Amersham Corporation
40 North Avenue
Burlington, MA 01803
tel (617) 272-2000
tel (800) 225-1383

In reference to docket number 71-9032, we are providing the additional information requested in your letter dated 17 February 1994.

The revisions are as described below and have been included as revised pages. All changes are indicated by a vertical line in the margin.

NOTED	
DATE	BY
1-1-79	J. J. [Signature]
APPROVED BY	FACTORY A
DATE	BY
1-1-79	J. J. [Signature]
APPROVED BY	FACTORY A
MATERIALS	
GENERAL OPERATIONS INC	
RADIATION PRODUCTS DIVISION	
INDUSTRIAL, MI, 48116	
DATE	BY
1-1-79	J. J. [Signature]
APPROVED BY	FACTORY A
DRAWING TITLE	
MOD. 690 URANIUM SHIELDED SOURCE CHANGER	
CLASSIFICATION	
REF. DWG. NO. 65002	
SCALE	SHEET 1 OF 3

65002

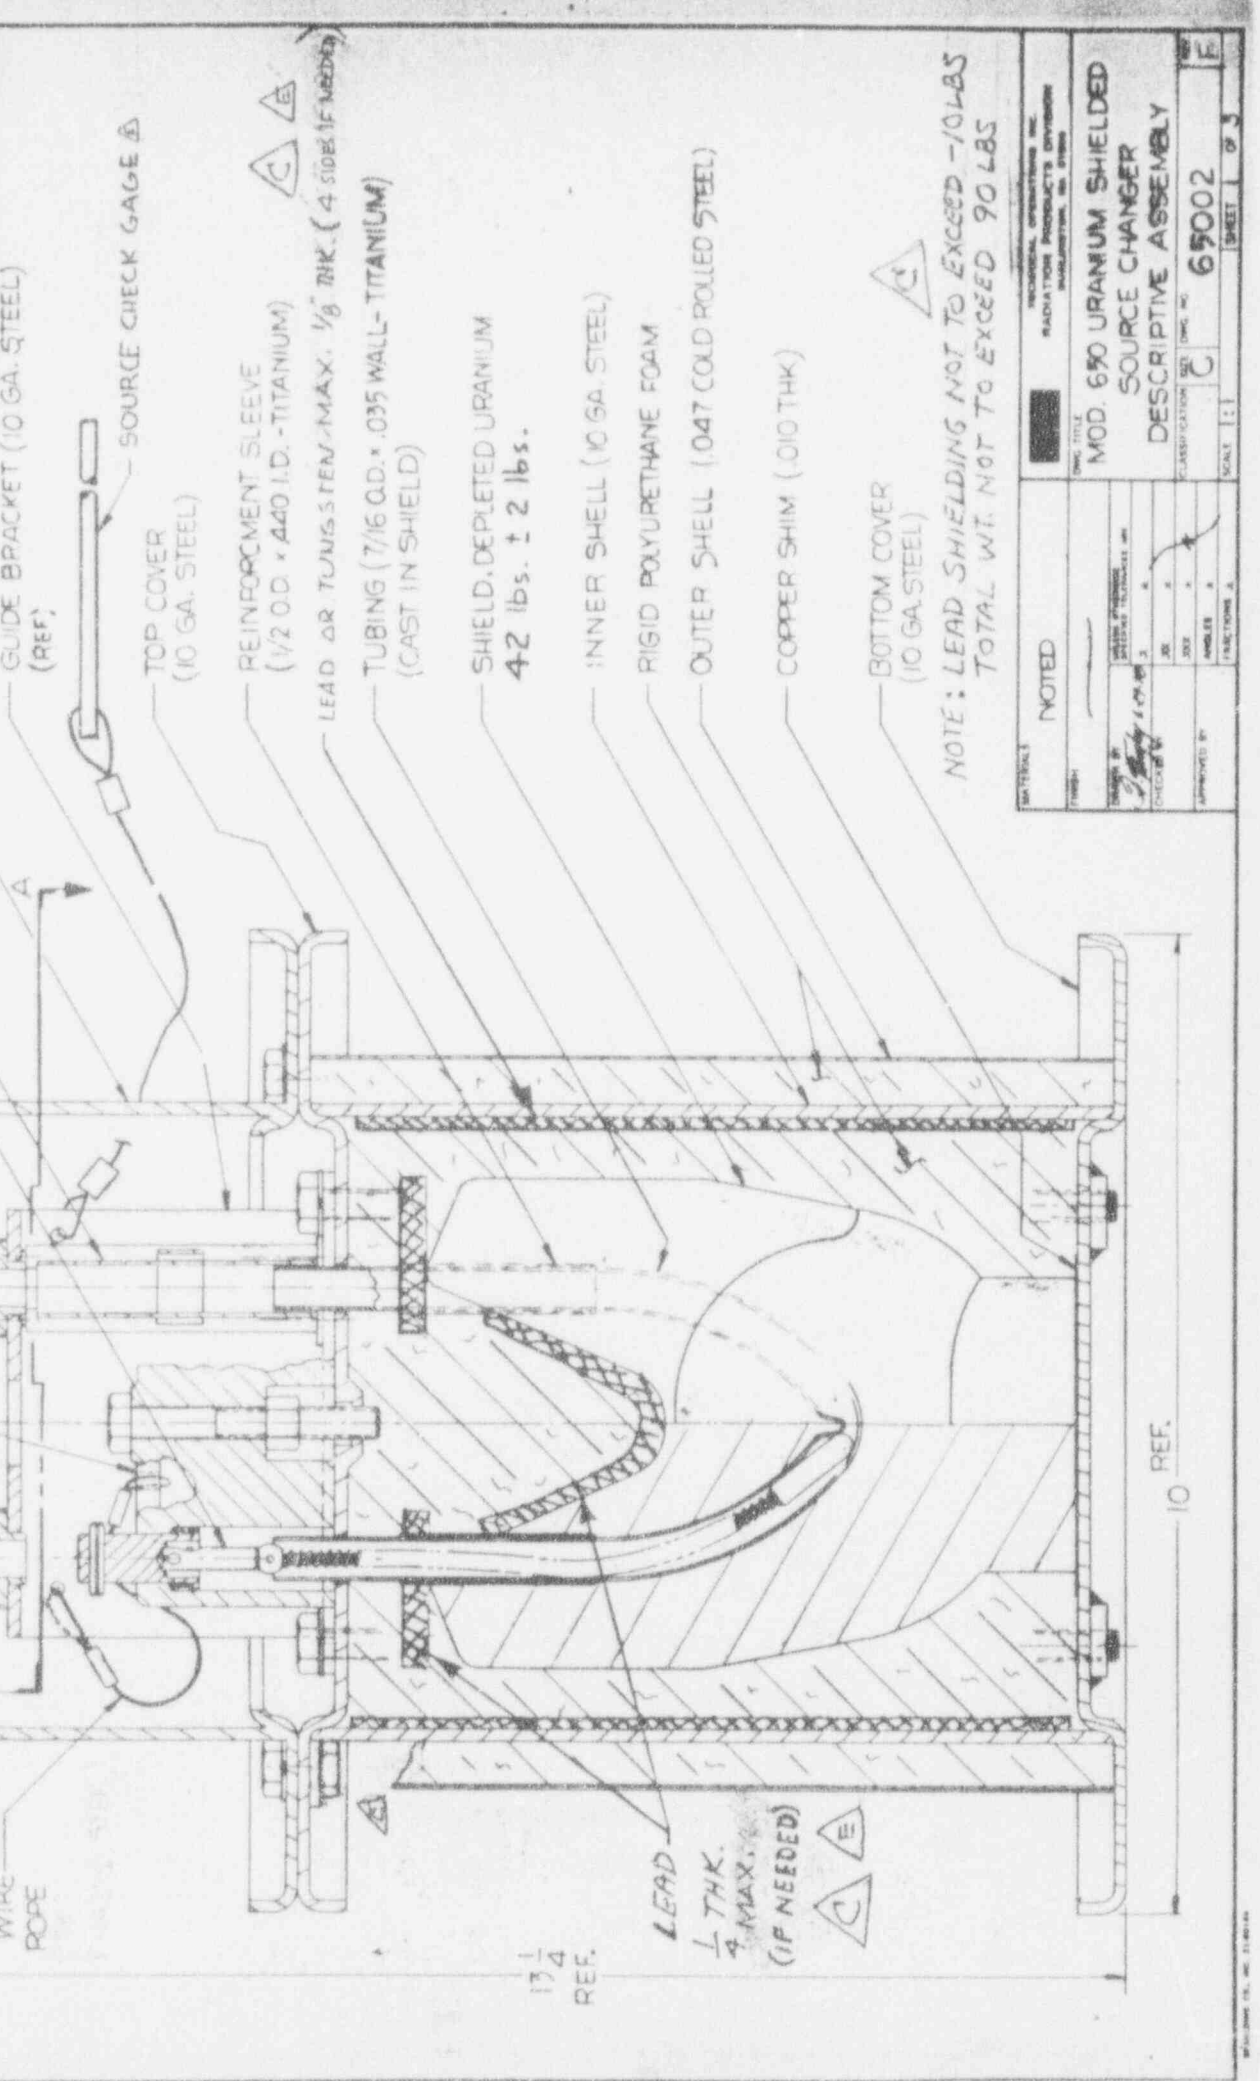
- 1) Drawing 65090 sheets 1-3 have been revised to reflect that the lead and tungsten thicknesses are maximum thicknesses.
- 2) The initial method of attachment of the supplemental shielding is glass tape secured around the supplemental shielding and the depleted uranium shield. The tape is used to properly position the supplemental shielding before the vultafoam is poured. The container is filled with vultafoam which cures and hardens and assures that the supplemental shielding does not move during use or as a result of the hypothetical accident conditions. As the foam is already specified on the drawings we have not revised the drawing.
- 3) Clearer copies of the drawings are enclosed.

NOTE: LEAD SHIELDING NOT TO EXCEED -10 LBS
TOTAL WT. NOT TO EXCEED 90 LBS

LEAD 1/4 THK. MAX. (IF NEEDED)
